PREPARED FOR THE URBAN DESIGN COMMISSION AND PLAN COMMISSION

Project Address: 516-530 Cottage Grove Road
Application Type: Conditional Use
Legistar File ID #: [35558](#)
Prepared By: Heather Stouder, AICP, Planning Division
Report Includes Comments from other City Agencies, as noted

Description and Analysis of Revisions and Supplemental Information

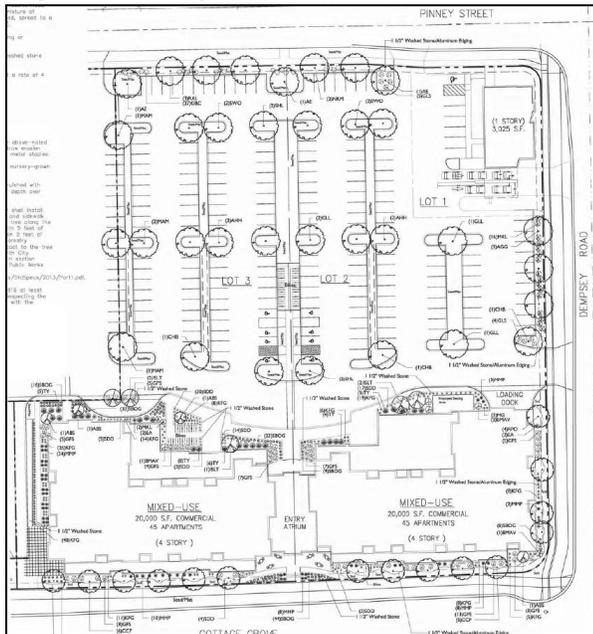
Parking and Circulation- The revised proposal has 185 surface parking stalls for automobiles, while the original submittal had 190. This slight reduction is the result of straightening out the drive aisle closest to the building and providing more space on the north side of the building for bicycle parking, landscaping, and gathering.

February 5, 2015 Landscape Plan

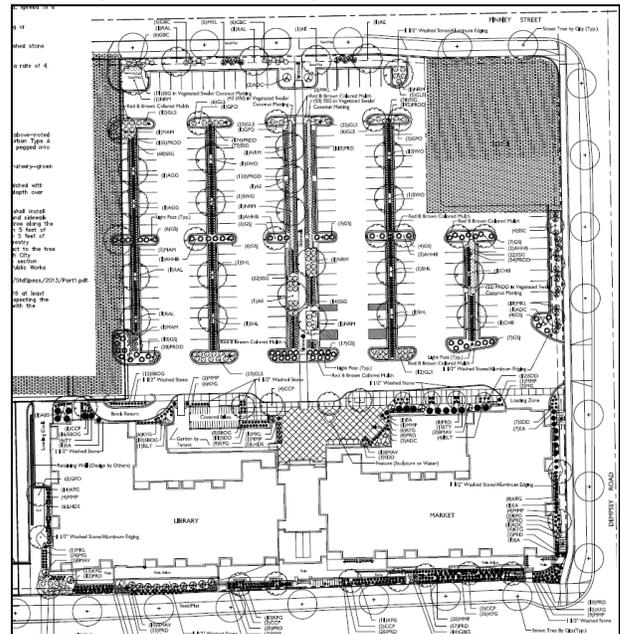
Landscaping and Other Site Details- The revised landscape plan provides for a better overall tree distribution in the surface parking area, and a significant increase in lower-level plantings (small trees, shrubs, and perennial grasses) in the landscaped areas between the parking rows. Landscaping near the building is similar, but a new garden area for the library space is provided, and there is a larger pedestrian space near the northern entrance to the building. On the whole, the landscaping points for the site have increased by over 20%.
